SUBJECT: Elizabeth Trace

SUBJECT: Elizabeth Trace
Property described as parcel number 12-26-204-038, on the south side of Elizabeth Lake Road and east of Union Lake Road, consisting of approximately 10.28 acres.
Request: **Preliminary site plan approval**

RE: Elizabeth Trace- Preliminary and Final Site Plan Review – 2nd Review

**Combined Preliminary – Final Site Plan Review
for
White Lake Charter Township, Michigan**

Existing Condominium Building

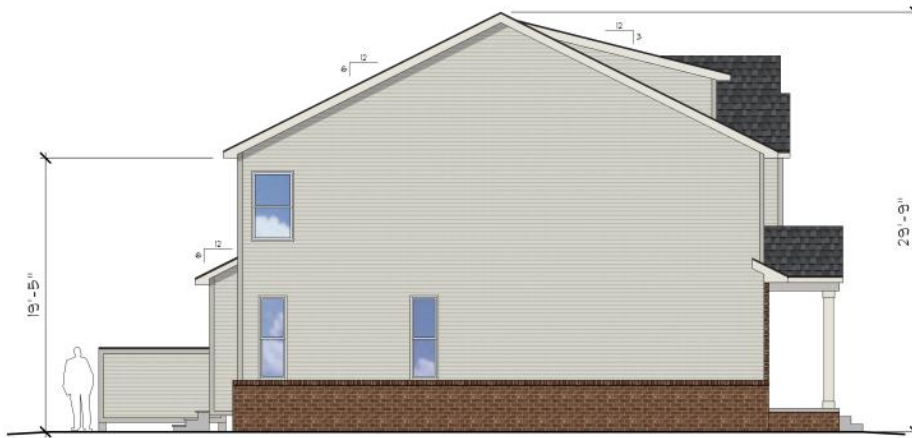
Commissioner Seward stated he did not like the straight flat rooflines in the front of the property. Mr. Eppink presented elevations. Commissioner Carlock said she wanted to see more brick on the buildings to be consistent with the existing buildings.

Commissioner Seward said he did not like the vinyl siding on the ends of the buildings. Mr. Eppink said he wanted to provide a modern living space and was constrained by setbacks and easements. The front exterior was articulated, and the interior living space was maximized.

The Planning Commission stated that the rear of the proposed buildings is not as aesthetically pleasing as the front of the buildings. They suggested a few cantilevers in the back over the windows. Director O'Neil said the Planning Commission can give the applicant guidance and it will be worked on within the Planning Department.

1. The amount of brick on the rear, and side elevations should be comparable with the existing buildings.

PH HOMES
OVERALL PLAN
 ELIZABETH TRACE SITE PLAN AMENDMENT
 TOWNSHIP: 3
 RANGE: 8 E
 SECTION: 26
 WHITE LAKE TOWNSHIP
 OAKLAND COUNTY
 MICHIGAN

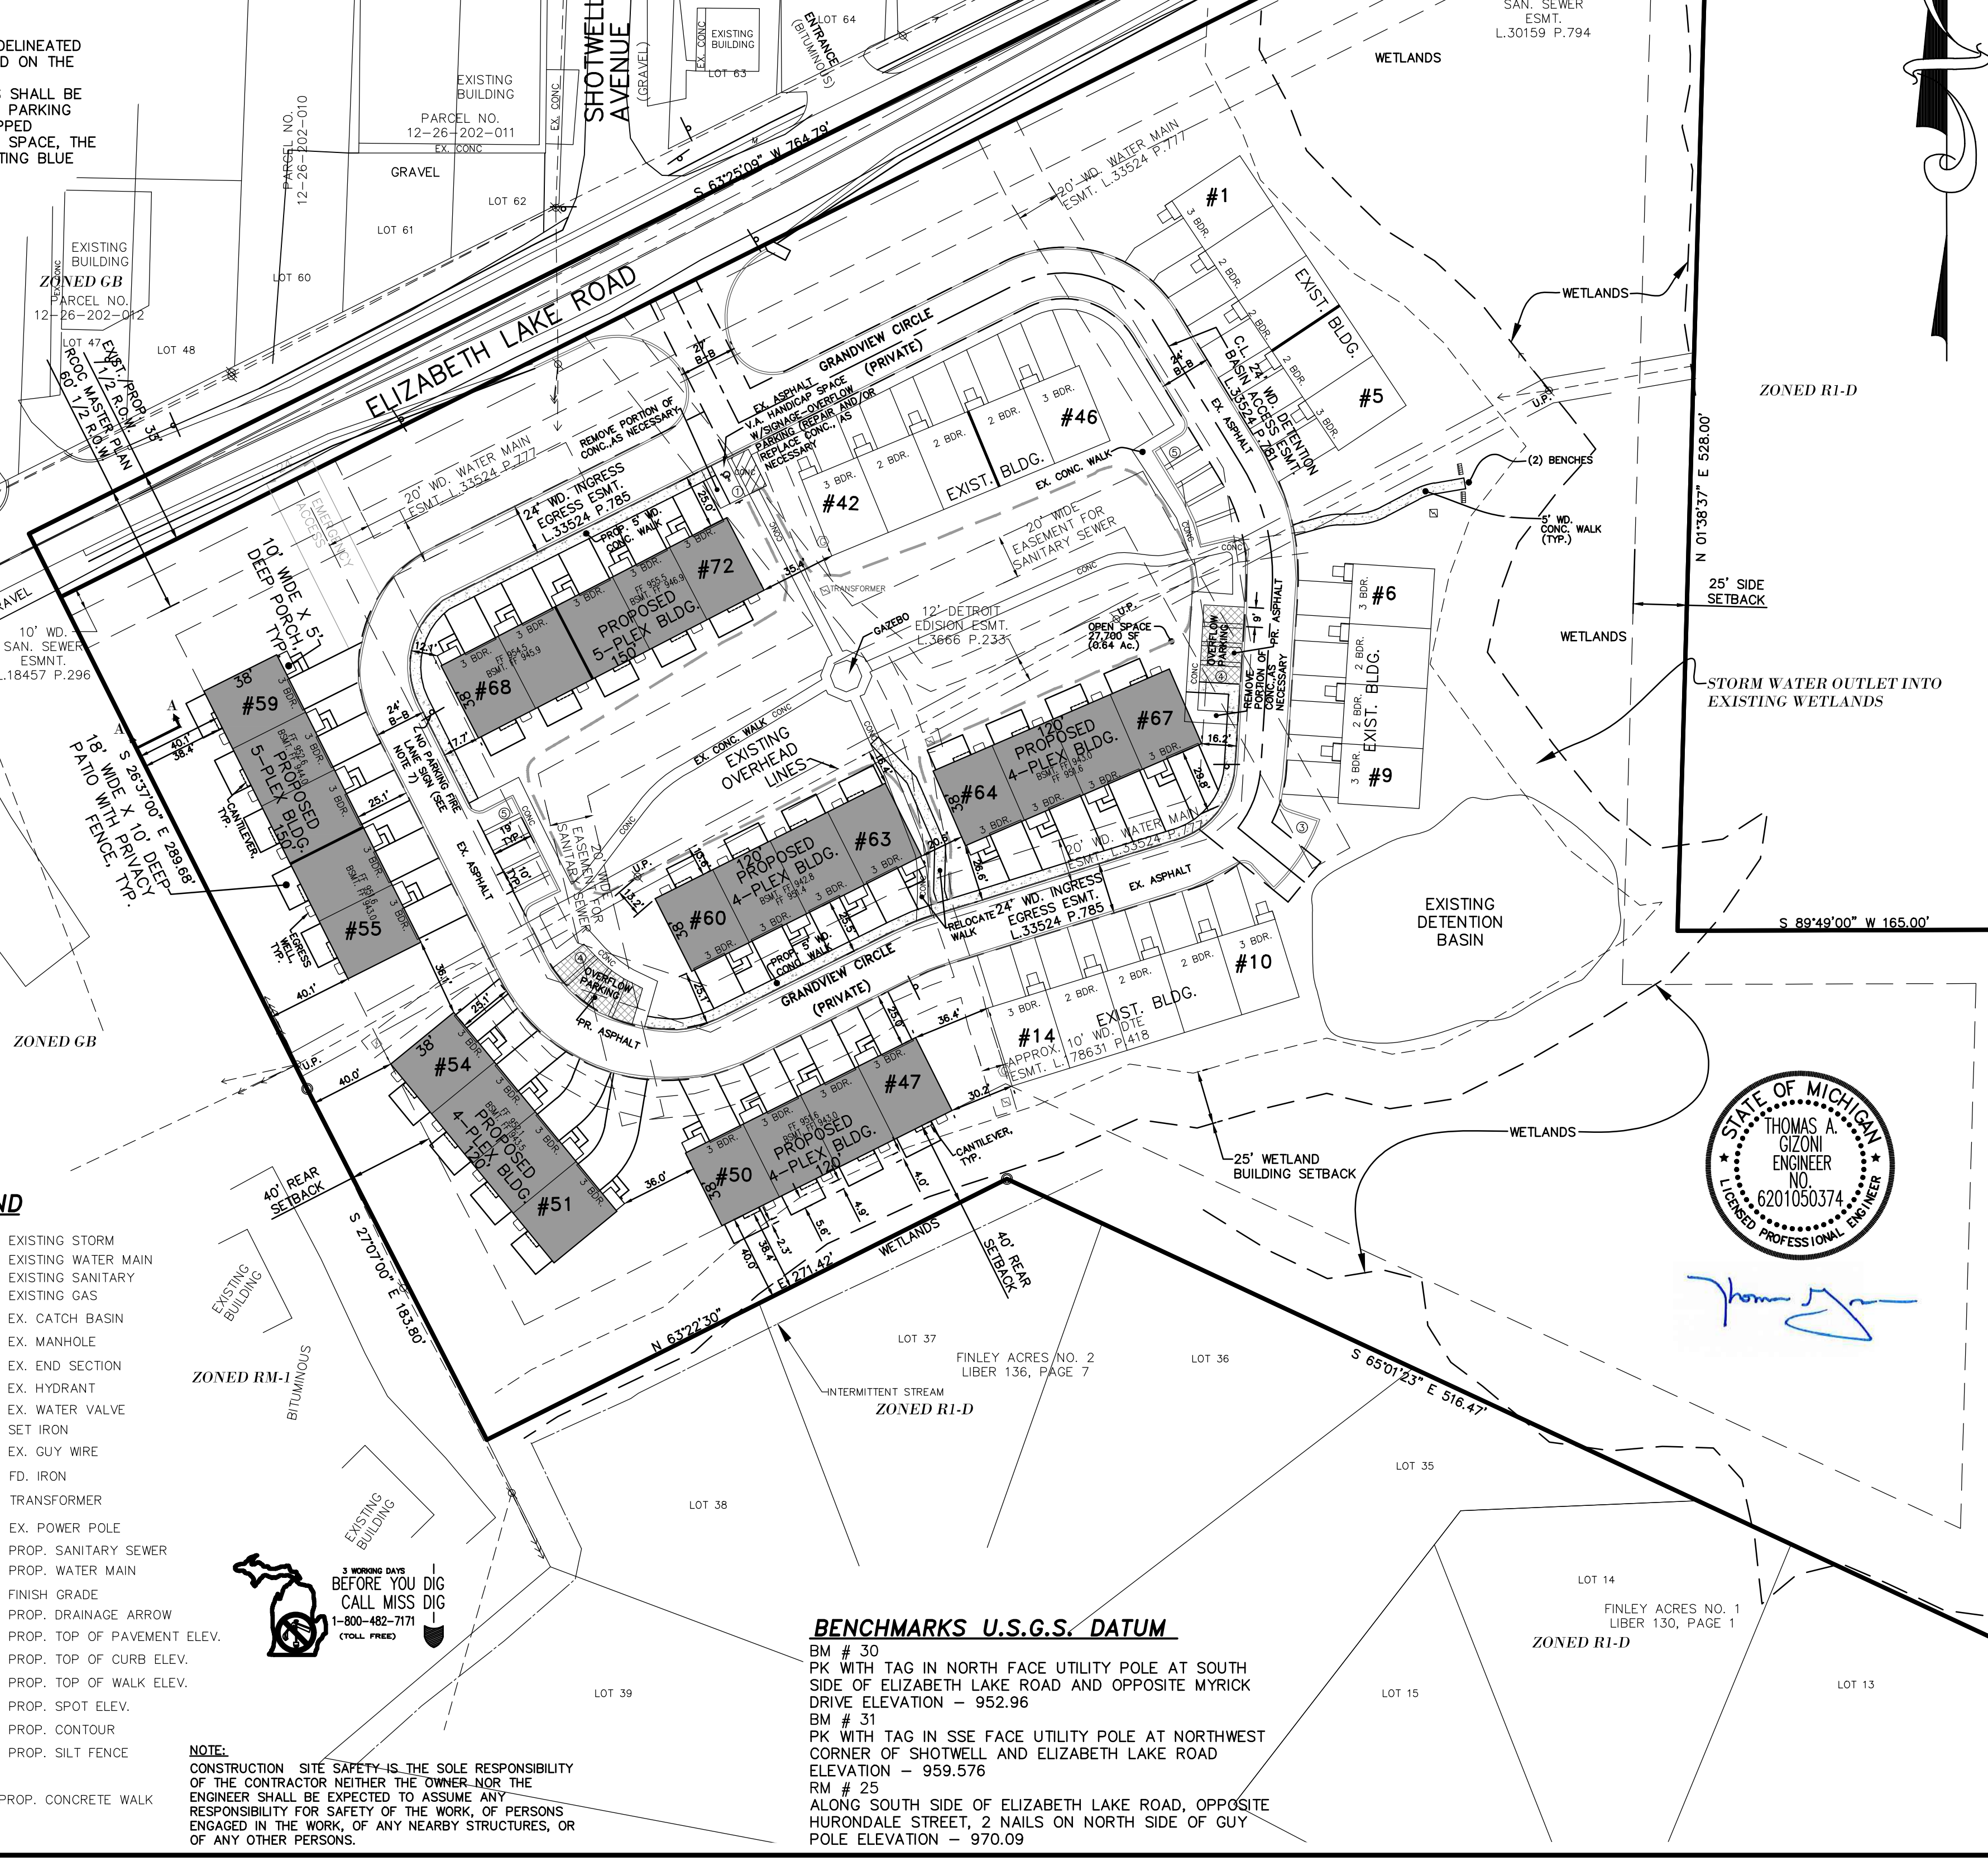
- 1) *The distance between the side of unit 59 and the front property line should be provided on Sheet*
- 2) *A variance is required from the Zoning Board of Appeals to allow the proposed distance between buildings 51-54 and 55-59, 60-63 and 64-67, and 72-68 and existing building 42-46.*

An emergency access drive is shown on Sheet 1 near the northwest corner of the site. The response letter dated February 6, 2025, states the drive is clear and accessible as designed. We defer to Township Engineering and public safety to review the emergency access drive.

Section 5.11 outlines requirements for off-street parking. Sheet 1 provides parking locations and calculations for residents, visitors, and overflow spaces. Parking is provided via two (2) garage spaces and two (2) driveway spaces per unit. Notes indicate that an additional twenty-two (22) parking spaces for guests and overflow parking are provided throughout the entire site.

Between the existing and proposed parking, the site will provide a total of two hundred and two (202) spaces. Section 5.11.M requires at least 75% of the maximum allowable number of parking spaces. The maximum number of parking spaces required is two hundred sixteen (216) parking spaces. The total site parking meets these requirements, however the one (1) ADA accessible parking space shown opposite the site's existing entranceway should be moved as it will require users to back into the entrance drive to exit the space.

Units 50 and 51's driveways are over the 20' wide easement for sanitary sewer as shown On Sheet 1. Unit nine's driveway also encroaches the easement, however this is an existing unit.

views indicate no site lighting is utilized in the existing portion of the site. A note should be added to Sheet 1 stating no site lighting is proposed for phase 2.

- 1) *A note should be added to Sheet 1 indicating no site lighting is proposed.*

SOIL EROSION AND SEDIMENTATION CONTROL PLAN

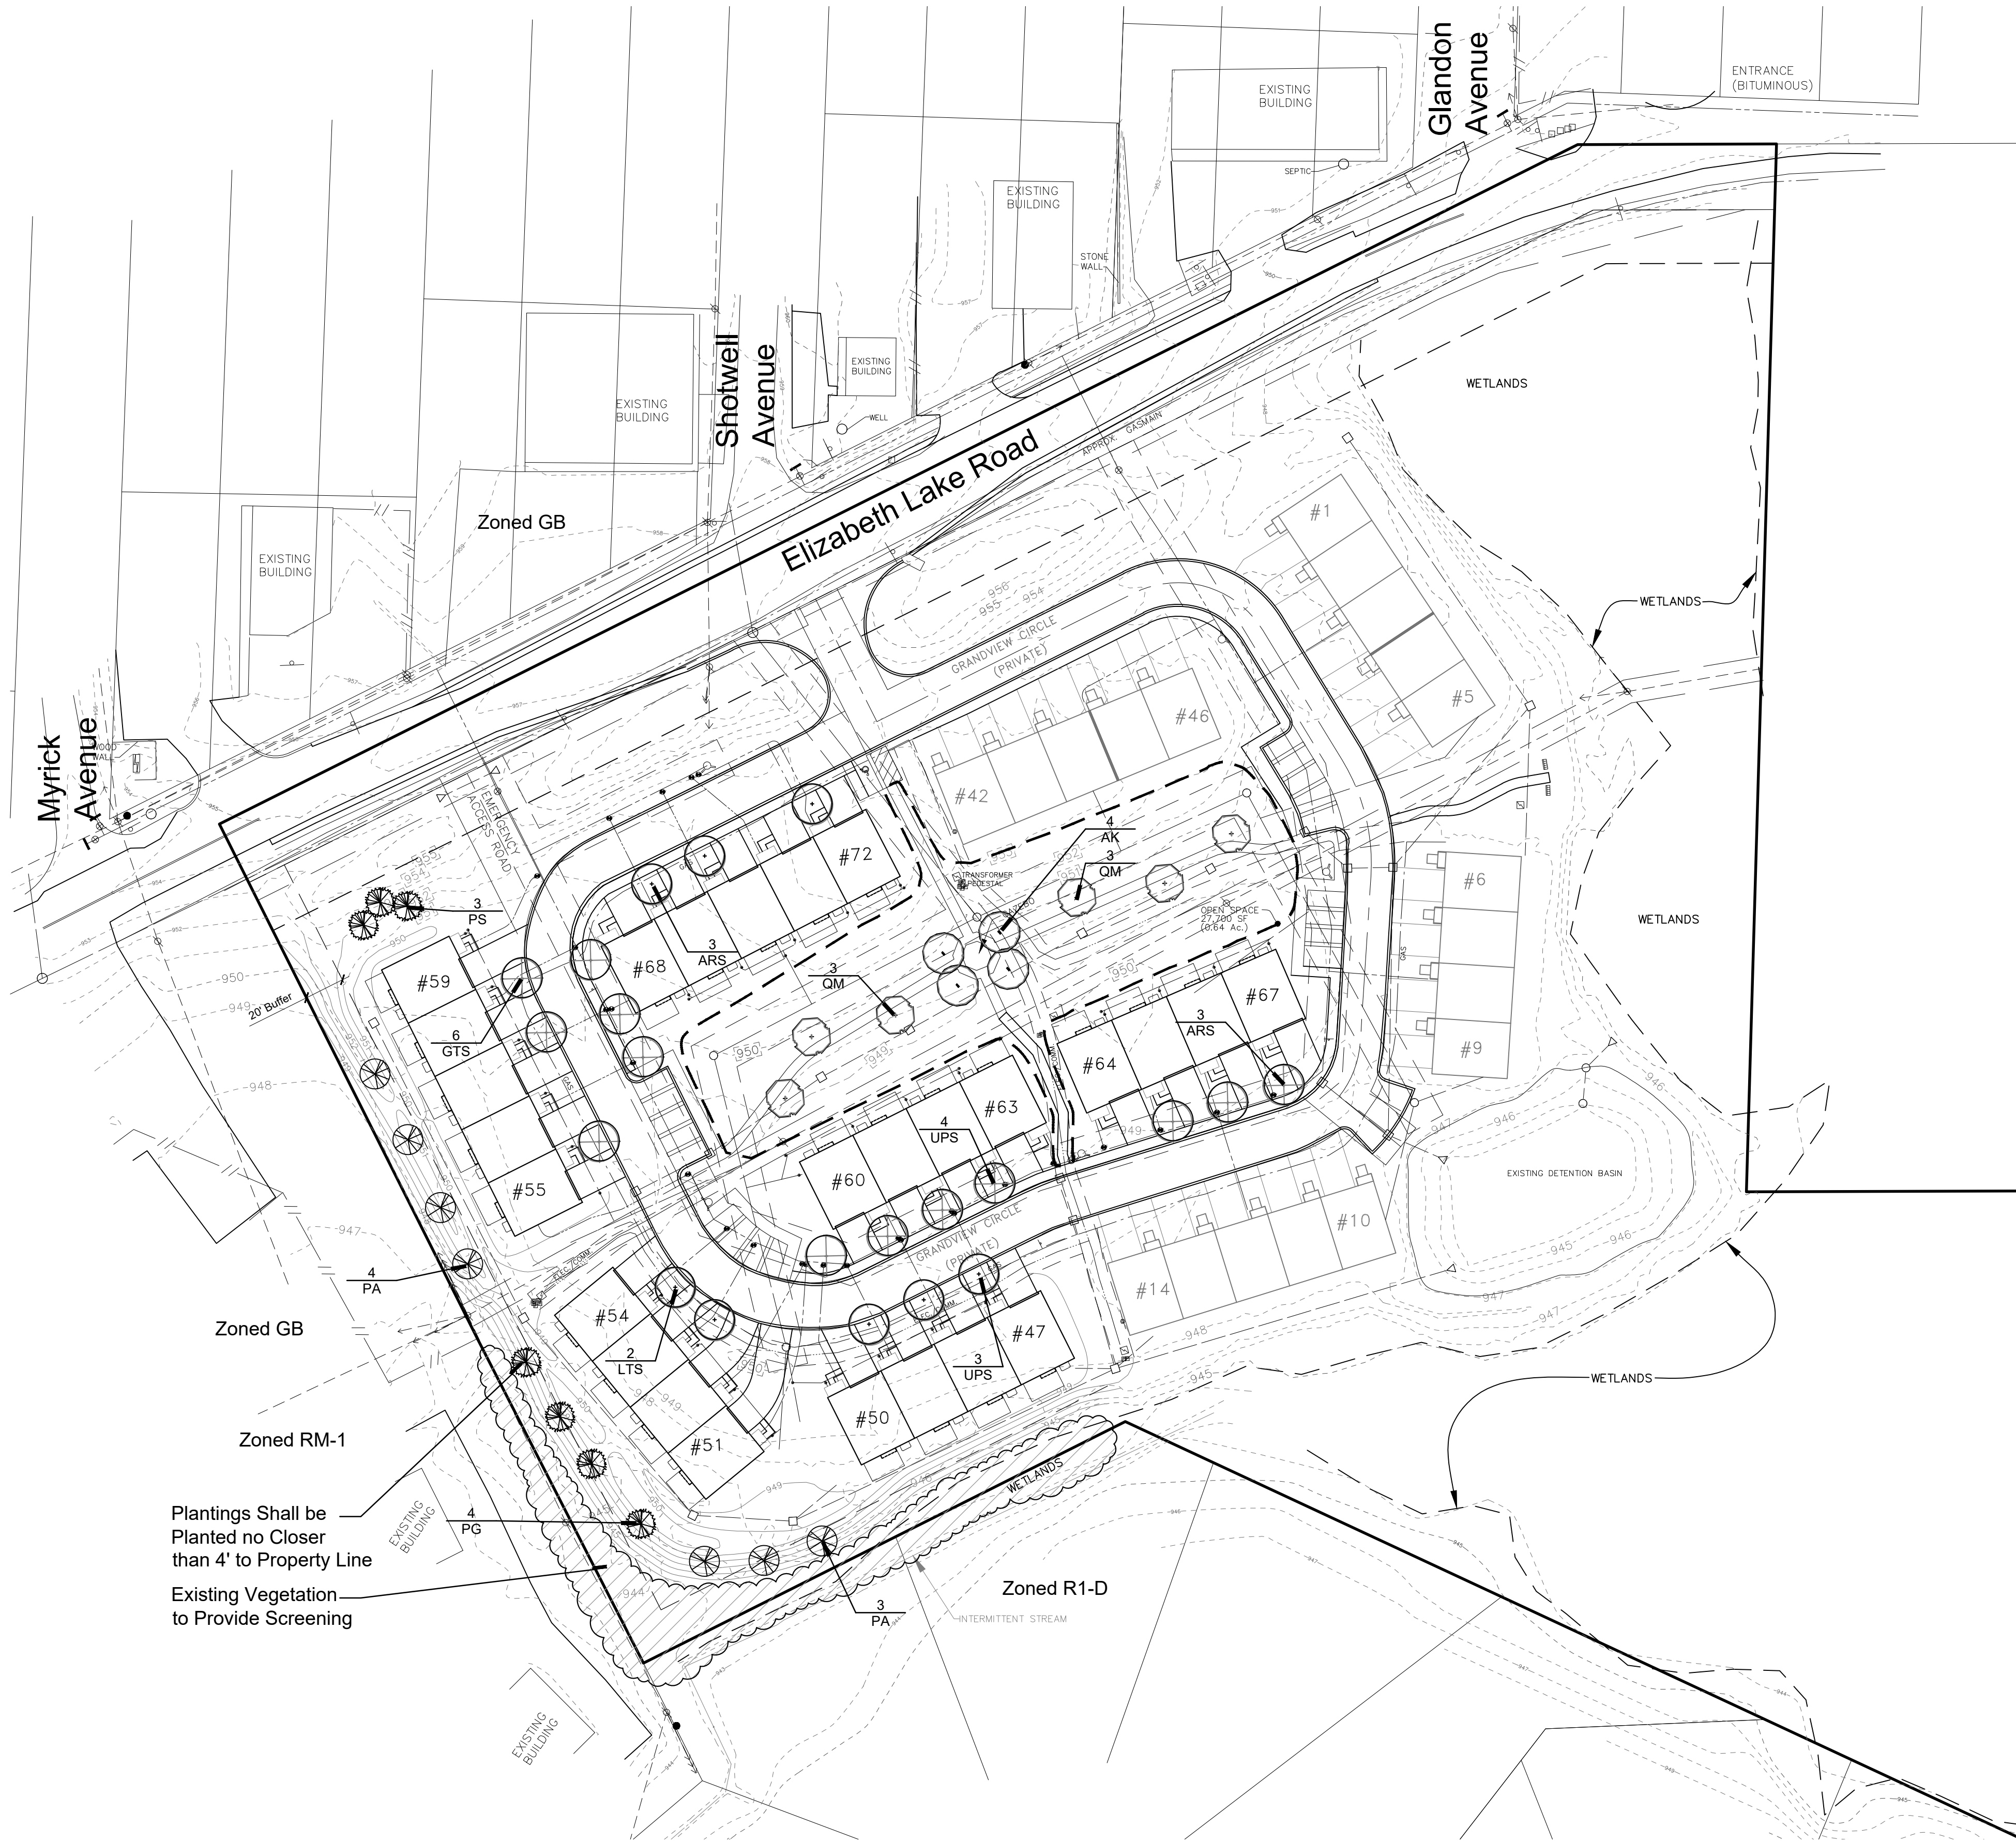
Soils: Sheet 4 states that sandy soils are present on the site.

Landscape Plan

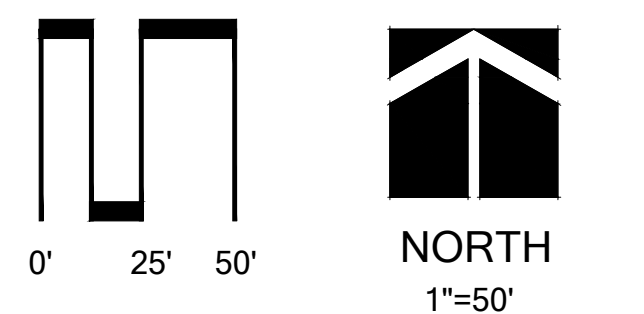
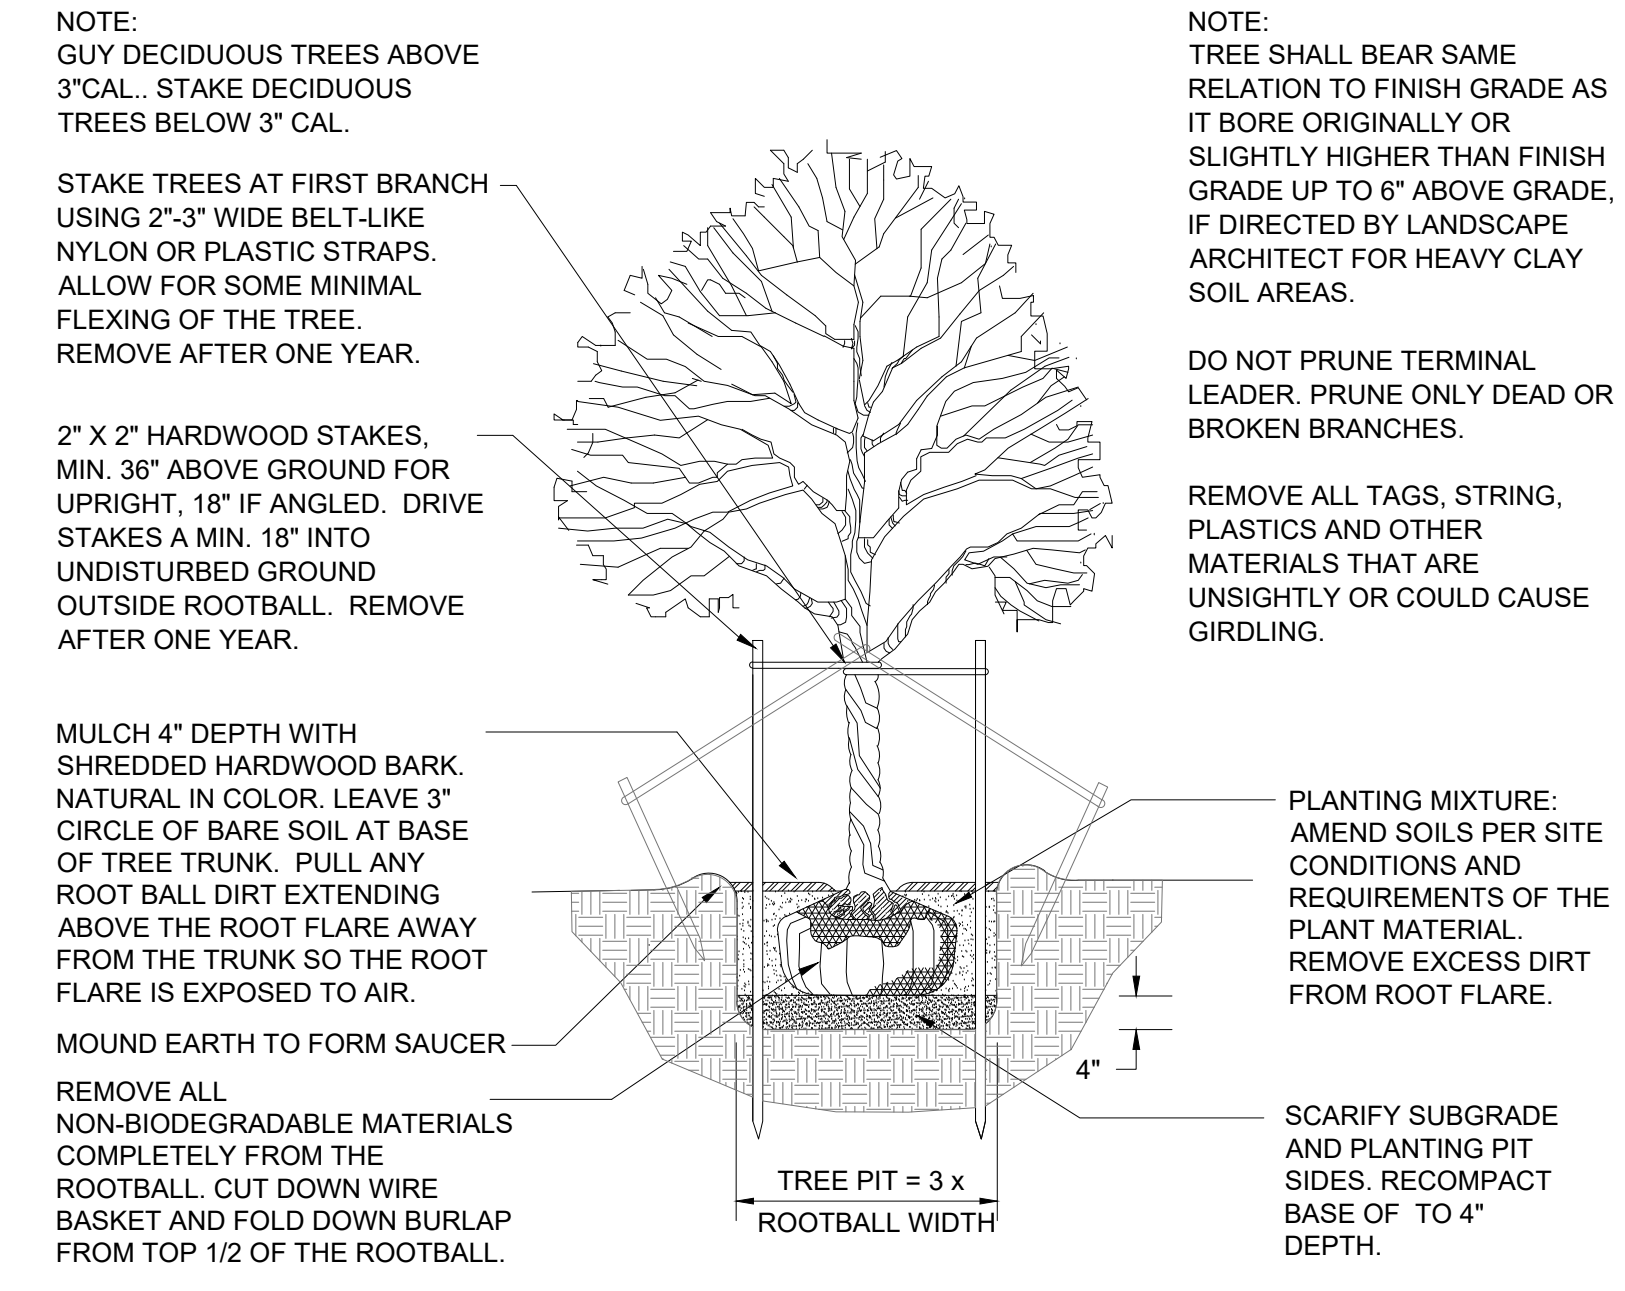
- j) *Sheet L-1- Proposed tree planting horizontal separation relative to water service leads shall be maximized. In addition, there are several areas where trees are proposed to be planted directly over water service lines (example Unit 61). Please relocate trees accordingly.*

- 1) *Notes on Sheet L-1 should be updated to show the correct total lot area requirements.*
- 2) *Planning Commission to consider waiver to allow for proposed greenbelt landscaping.*
- 3) *Planning Commission to consider waiver to allow for proposed interior landscaping.*
